Submissions Report

Monaro Rock Quarry

Development Application No. SSD- 27223807

Figure 3.1
PRINCIPAL PROJECT COMPONENTS

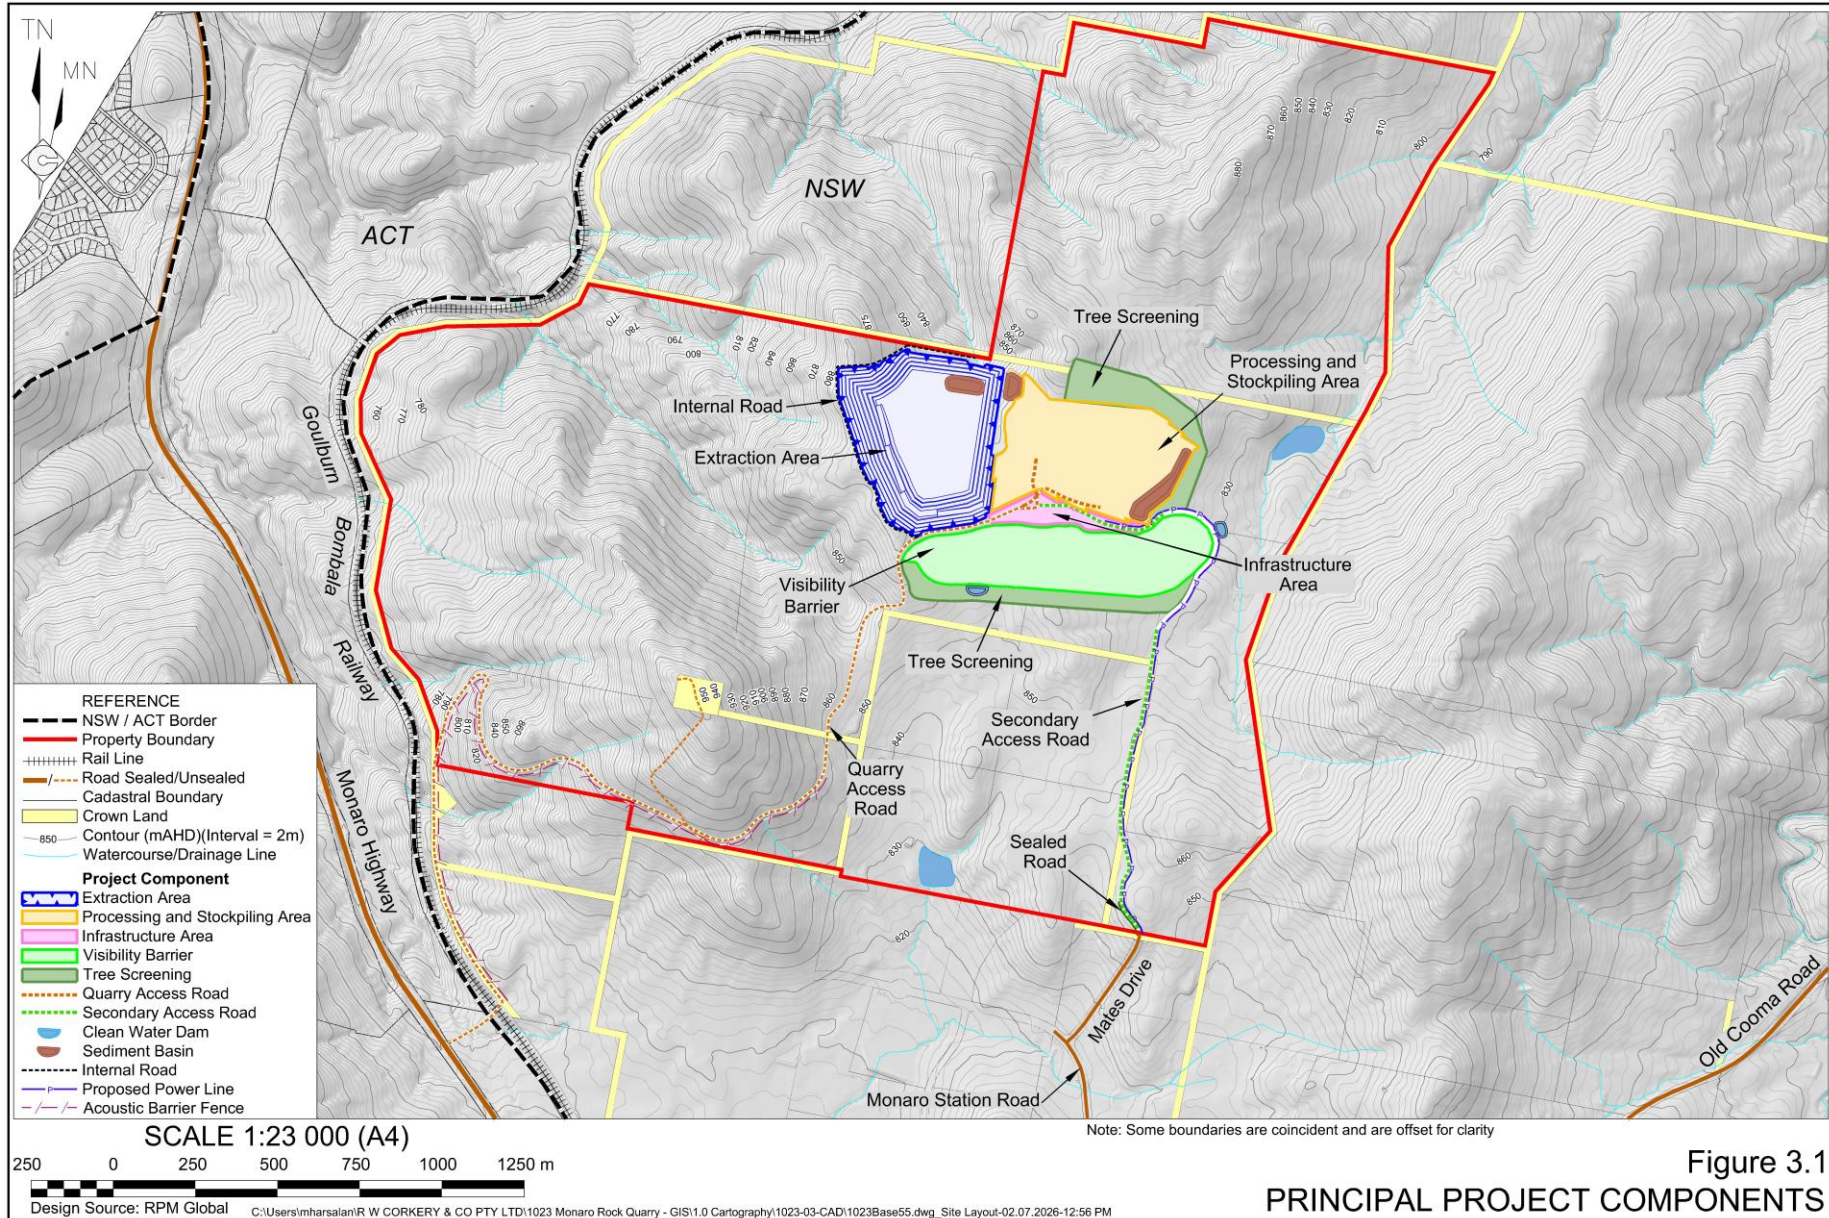
Authority to use, traverse, access, or construct infrastructure on Crown land and roads is required under the Crown Land Management Act 2016 and/or the Roads Act 1993. It is recommended that the proponent contact Crown Lands as early as possible to discuss and initiate the necessary processes to authorise the use of and/or access to Crown land and roads. If infrastructure is to be built on Crown land or roads, consent from the Minister for Water, Property and Housing (via Department of Planning, Housing and Infrastructure | 25/07992#19 5 Crown Lands) will be required. Constructed roads may also need to be transferred to Council.

Figure 3.1 presents the principal components of the Project and includes where access to the Project Site would cross or use Crown roads. The Applicant will continue consultation with Crown Lands to determine the appropriate tenure and approval pathway for any Crown roads required for access or infrastructure. These arrangements would be finalised before commencement of the Project should an approval be granted.

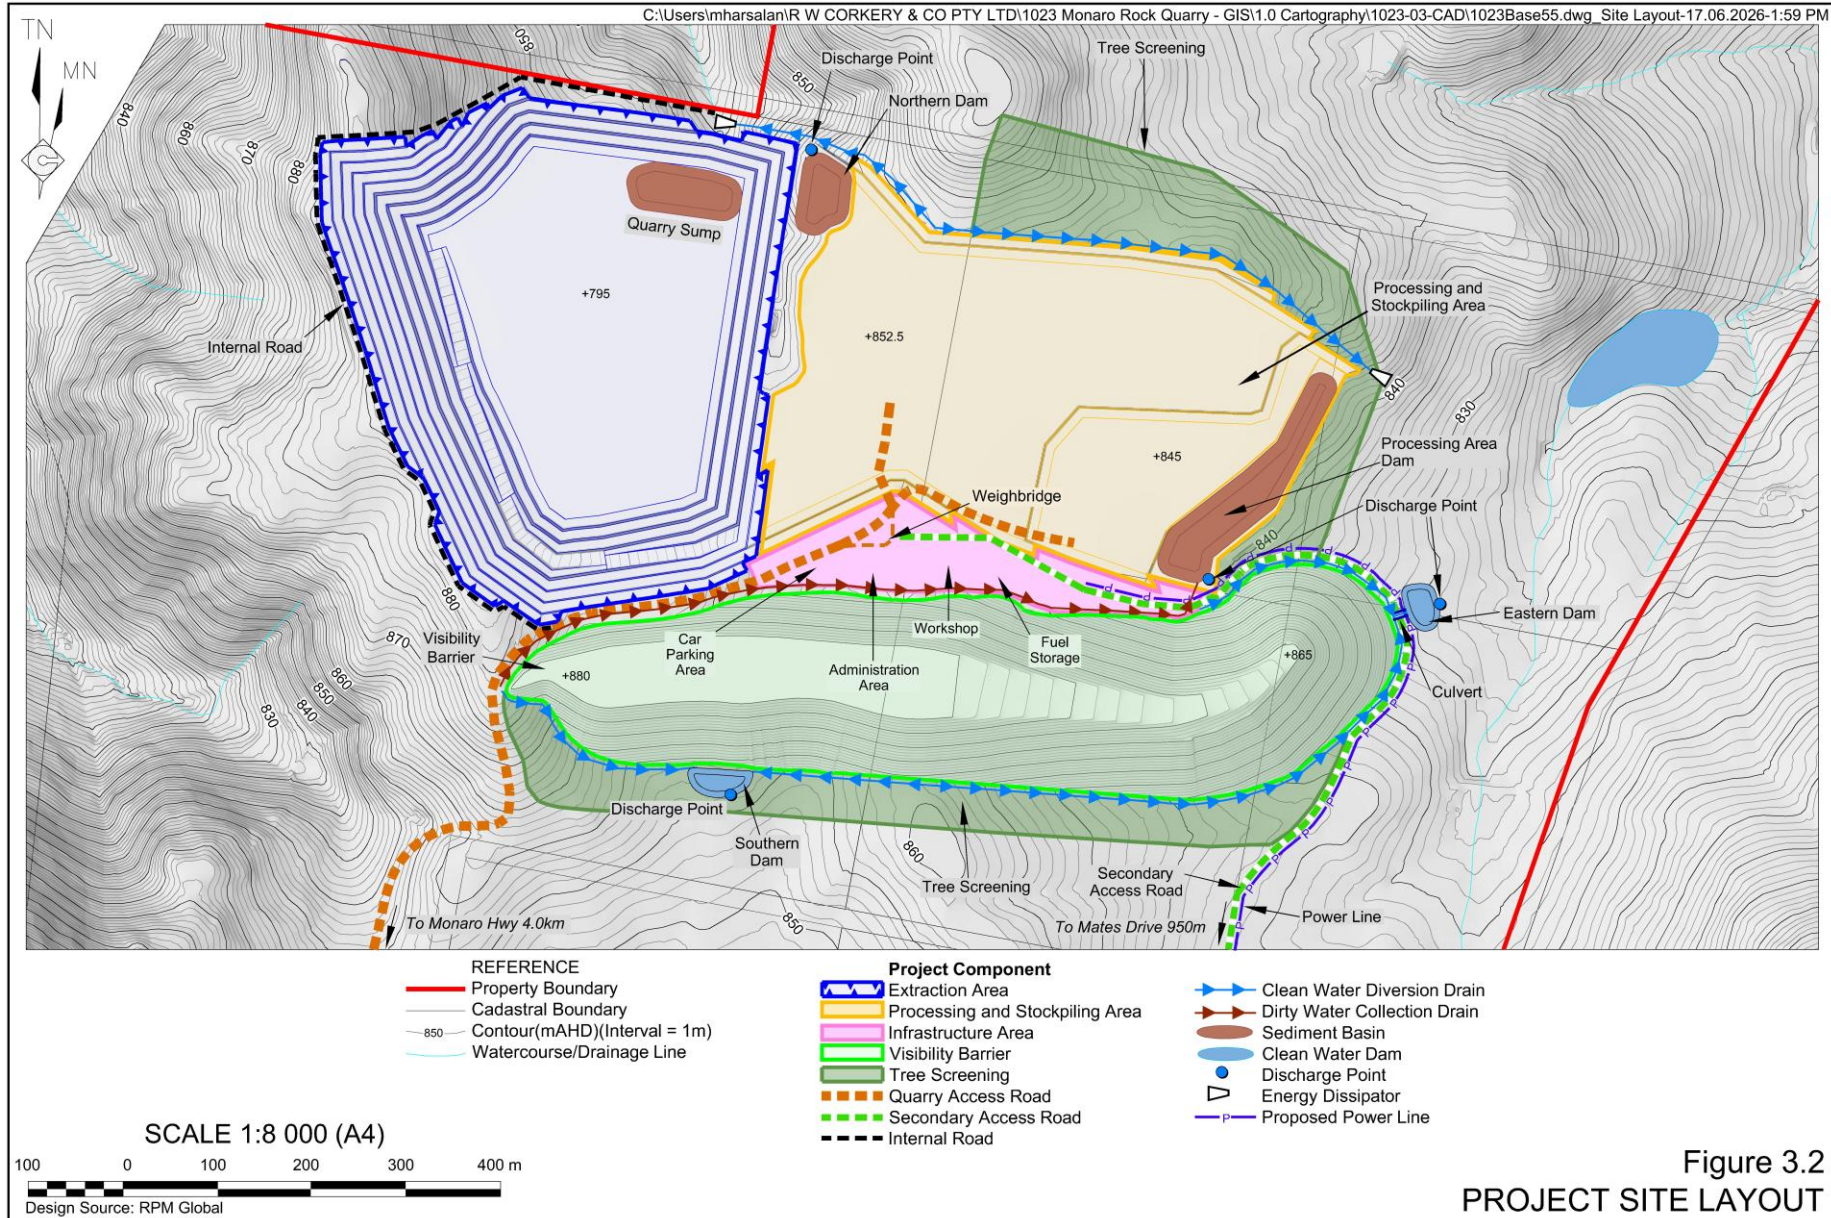
The EPA considers the grading of access roads twice per month to be routine maintenance, therefore as per Fact Sheet C of NPfI the duration correction does not apply to this activity. The NVIA needs to include management/mitigation measures to reduce the impact from grading, or seal the section of road closest to sensitive receivers to minimise noise levels to achieve the criteria without the duration correction applied.

To reduce the noise impacts to the receivers nearest to the Secondary Access Road, the first 120m of the Secondary Access Road would be sealed as presented **Figure 3.2** and Appendix C of the updated NVIA. Noise modelling for operational impacts was updated to include graders along the unsealed portion of the Quarry Access Road and Secondary Access Road only, and results indicate that noise levels would comply with the relevant noise trigger levels at all nearby sensitive receivers.
